Access Compliance Report

Public Rights-of-Way

(Curb Ramps)

Intersection ID: 29751	Main Street: ARMORCREST_LN	Cross Street: KING_ARTHUR_DR	Location: W
ADA ID: 14527EBE9AEE	Ramp Type: PerpDiag	Initial Pass/Fail: Fail	Overall Compliance: No
Severity Score: 21.25			
Codes/Mitigation Info/Possible Solution		Field Measurements/Component Compliance

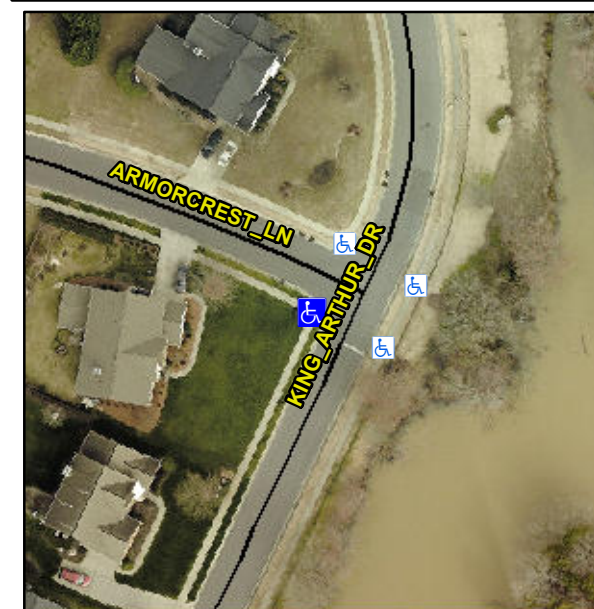
Not Found, R304.5.1, R304.2.2

Compliance	Description	Data	Compliance	Description	Data
N/A	Ramp Length (in)	48.0	No	Ramp Slope (%)	9.9
No	Ramp Width (in)	38.0	Yes	Ramp XSlope (%)	0.7
N/A	Flare Type LT	N/A	N/A	Flare Type RT	N/A
N/A	Flare Slope LT (%)	N/A	N/A	Flare Slope RT (%)	N/A
N/A	Flare Traversable LT?	N/A	N/A	Flare Traversable RT?	N/A
N/A	Landing Length (in)	N/A	N/A	DWS Provided?	N/A
N/A	Landing Width (in)	N/A	N/A	DWS Contrast?	N/A
N/A	Landing Slope (%)	N/A	N/A	DWS Length (in)	N/A
N/A	Landing X Slope (%)	N/A	N/A	DWS Full Width?	N/A
N/A	Landing Curb? (Y/N)	N/A	N/A	DWS Offset (in)	N/A
N/A	Shared Landing?	N/A			
N/A	Gutter Ponding?	N/A	N/A	Gutter Slope (%)	N/A
N/A	Gutter Lip Ht (in)	N/A	N/A	Gutter X Slope (%)	N/A
N/A	Painted X Walk1?	No	N/A	Painted X Walk2?	No
	X Walk 1 Direction	To SE		X Walk 2 Direction	To NE
N/A	X Walk 1 Width (in)	N/A	N/A	X Walk 2 Width (in)	N/A
	X Walk 1 Slope (%)	2.3		X Walk 2 Slope (%)	1.8
	X Walk 1 X Slope (%)	0.4		X Walk 2 X Slope (%)	2.3

Remove & Replace Curb Ramp With Two New Directional Ramps or Equivalent.
